## C. DIGITAL I&C REVIEW PROCESS

***Figure C.1 Digital I&C Licensing Process Flowchart***

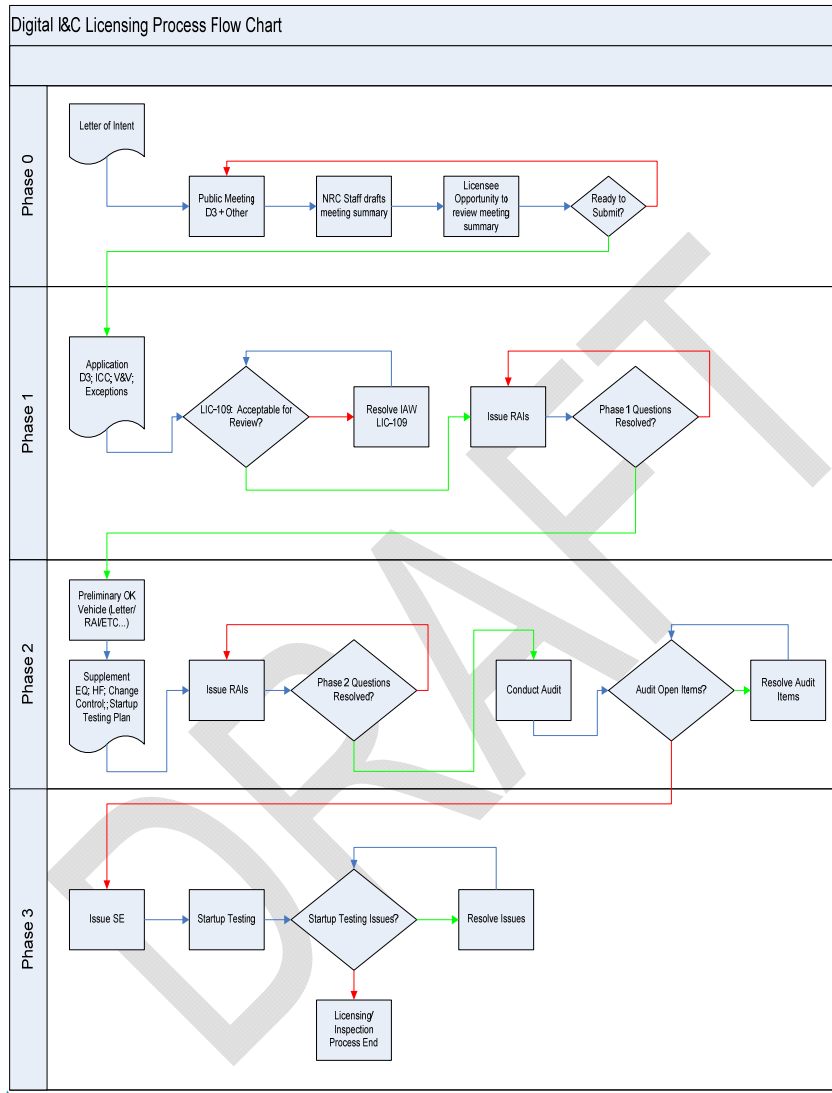
~~A~~ ~~Figure C.1 below is a~~ flow chart of the overall review process ~~is included in Enclosure C and This figure illustrates~~ the various review phases are further discussed in Sections C.2 through C.5.
